**RAM AIRCRAFT, L.P.  
SERVICE BULLETIN**

**SB2017-02**

**SUBJECT:** Exhaust Coupling, V-Band (p/n 2177-300) – Possible Improper Spot Weld

**PURPOSE:** Recall Non-Conforming Parts

**FIGURE 1: 2177-300 V-BAND COUPLING**

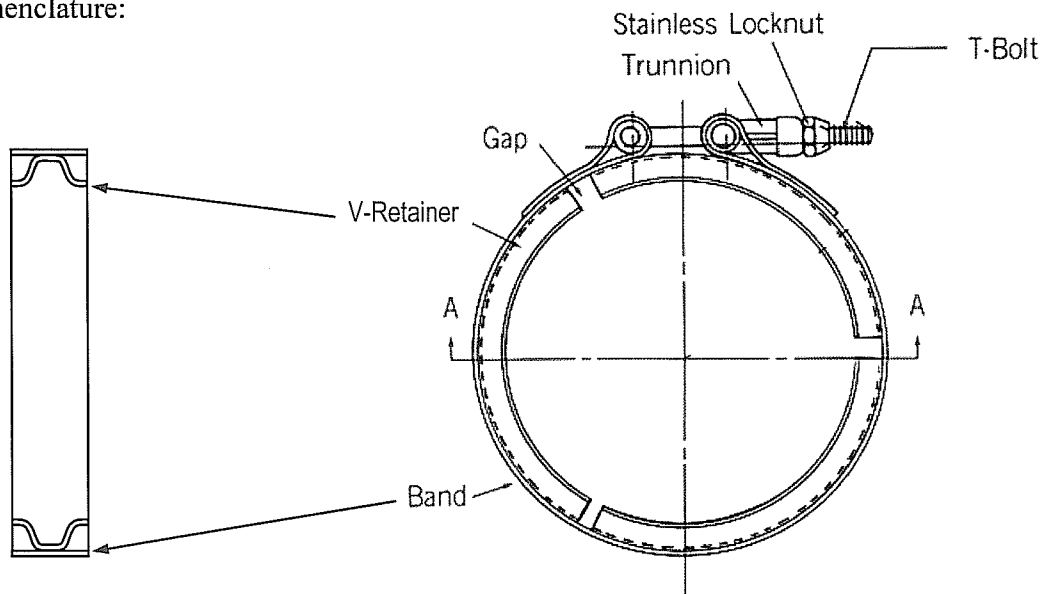
3. Spot-welds not centered on v-retainer and band as shown in Figure 3 are non-conforming.
    4. Gaps not evenly spaced within circumference are non-conforming. See Figure 1.

**FIGURE 2**  
**Exhaust Joint Assembly (Coupling Properly Installed)**

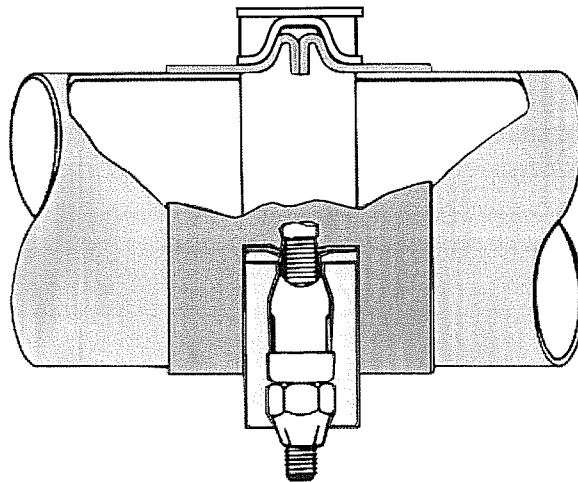
1. Couplings not in the proper location as shown in Figures 2 & 3 are non-conforming.
    2. V-retainers not centered in band as shown in Figure 3 are non-conforming.
